ORIEL WIND FARM PROJECT: N33 ONSHORE CABLE INSTALLATION

Stage 1 Road Safety Audit

MDR1520CRp0005
Stage 1 Road Safety Audit
S4.P01
14 Apr 2025

ORIEL WIND FARM PROJECT: N33 ONSHORE CABLE INSTALLATION**4.2 Problem 4.2****Location:** Scheme wide**Summary:** Restricted Visibility of existing farm entrances

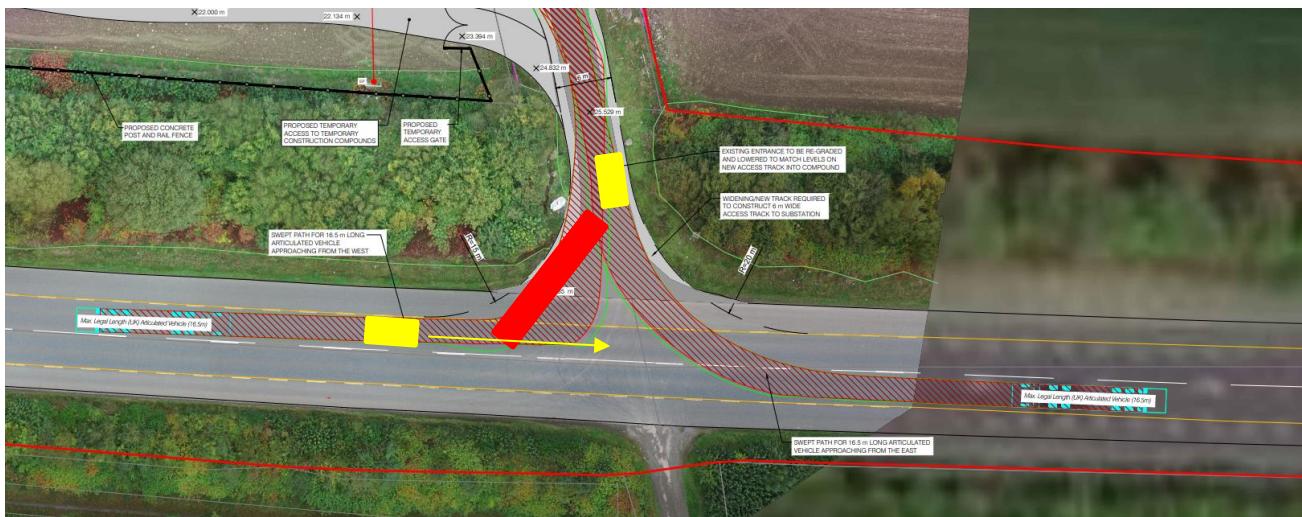
Some of the existing farm entrances along the N33 appeared to have restricted visibility. If these accesses are to be used for construction or maintenance of the cable routes, there is a risk of side-on or rear-end collisions between N33 traffic and construction vehicles exiting these assesses.

It is recommended an assessment of visibility to be carried out for these site entrances if construction and maintenance access is required.

4.2	Yes	Yes	4.2 Yes Yes Visibility assessments have been carried out for all N33 access points. It is noted that during construction all movements in and out of the side will be under full TTM and will involve left-in left-out restrictions. It is also noted that these existing field entrances are intended to be used for construction vehicles to access the works from the hard shoulder (which will be part of the protected works site) rather than access the N33.	Yes

4.3 Problem 4.3

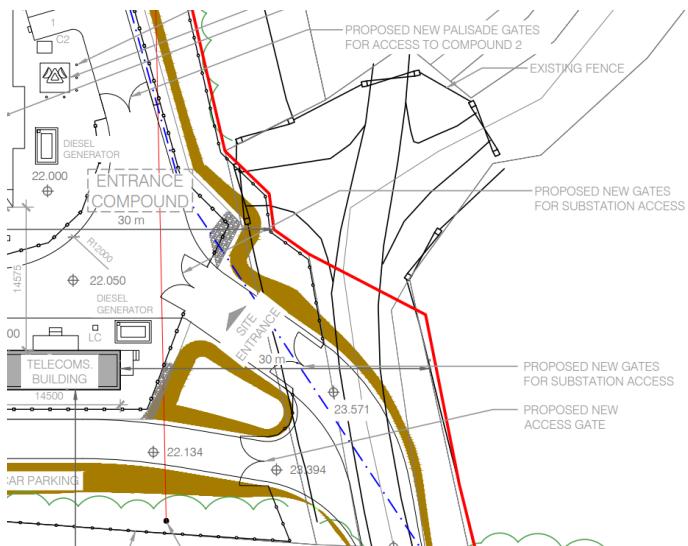
Location: Proposed Entrance into the substation

Summary: Articulated HGV entering the substation partially blocking the eastbound lane of N33

At the proposed site entrance at the substation, the proposed widened track appears to be of insufficient width to accommodate two-way vehicular movements. In the situation that a HGV entering the site encounters the oncoming traffic exiting the farm/the substation, the HGV may be partially blocking the N33 eastbound carriageway lane to yield to oncoming traffic. This could lead to rear-end collision between N33 eastbound traffic and the yielding HGV, or head collision if traffic swerves to avoid the yielding HGV and crosses into the opposing N33 lane.

The access arrangements should be designed so as to provide adequate facilities to ensure that the all vehicles turning into the substation entrance will not impede in anyway, the N33 traffic.

4.3	Yes	No	HGVs will only use this access during the construction stage, during which TTM will be in place to ensure movements in/out do not stop on or block the N33. It is not considered necessary to cater for 2-way traffic in the permanent operational situation due to low volumes of movements and small sized vehicles.	Yes
